**PLANNING COMMISSION STAFF REPORT
ADMINISTRATIVE ITEM**

**PLNPCM2010-00823
Sugar House Apartments
Building and Site Design Review
2025 & 2033 South 1200 East
March 9, 2011**

Applicant: Gardiner Properties

PAGE TITLE
SITE PLAN PROPOSED

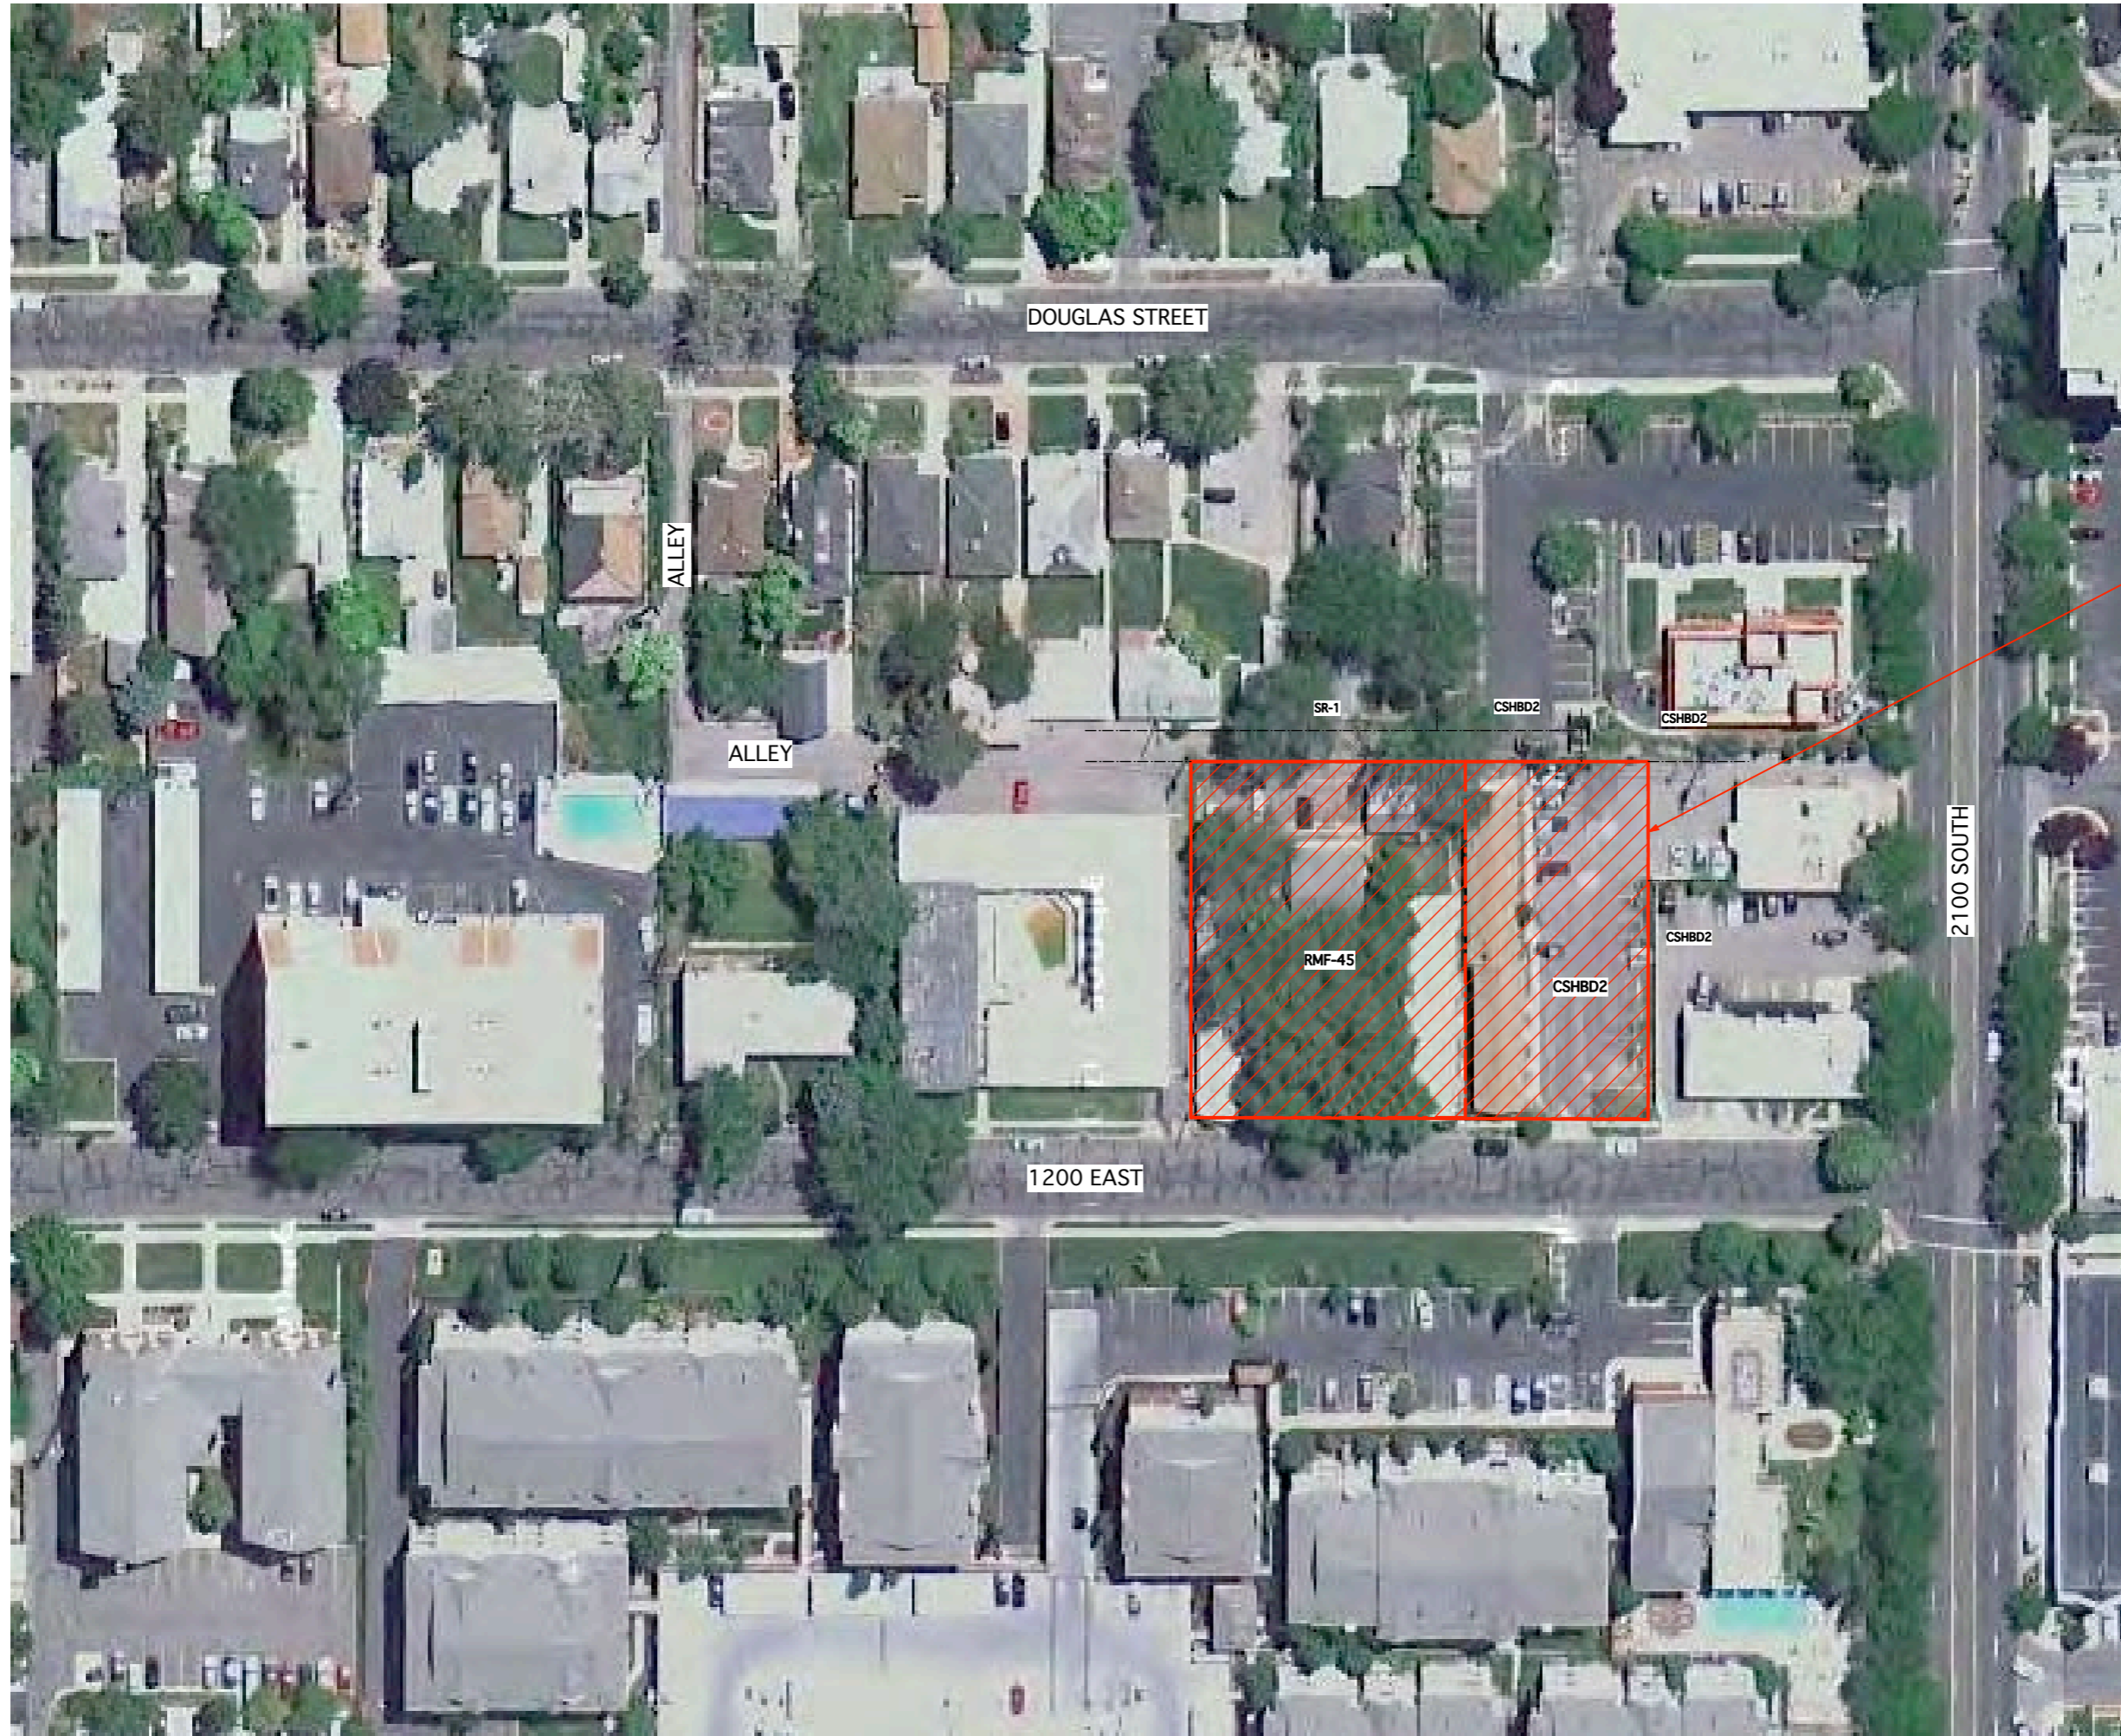
Analysis: The preliminary lighting plan shown on the proposed site plan generally meets Chapter 4 of the Salt Lake City lighting master plan. Staff recommends that the development be required to meet Chapter 4 of the Salt Lake City lighting master plan as a condition of approval.

Analysis: The preliminary landscape plan shown on the proposed site plan generally meets the City's landscaping requirements and Standard L. Street trees will line 1200 East. Staff recommends that the development fully meet the City's landscaping requirements set forth in 21A.48 as a condition of approval. There are no existing street trees along 1200 East.

J. Lighting shall meet the lighting levels and design requirements set forth in [chapter 4](#) of the Salt Lake City lighting master plan dated May 2006. (South building conforms see SD1.1,)

5. Landscaping design shall include a variety of deciduous and/or evergreen trees, and shrubs and flowering plant species well adapted to the local climate. (South building conforms see Renderings, SD1.1,)

1. Any development fronting on a public or private street shall include street trees planted consistent with the city's urban forestry guidelines and with the approval of the city's urban forester. (South building conforms see Renderings, SD1.1,)

1 BIKE RACK DETAIL
SD1.3 Scale: 3/4" = 1'-0"

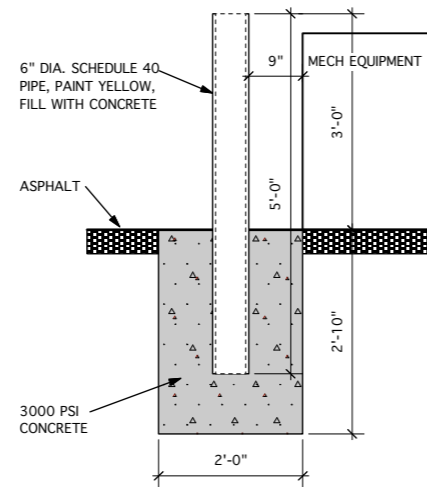
The bike stalls (5% = 5) are noted but detail reference per city standards is needed. (bike rack detail is provided on SD1.3)
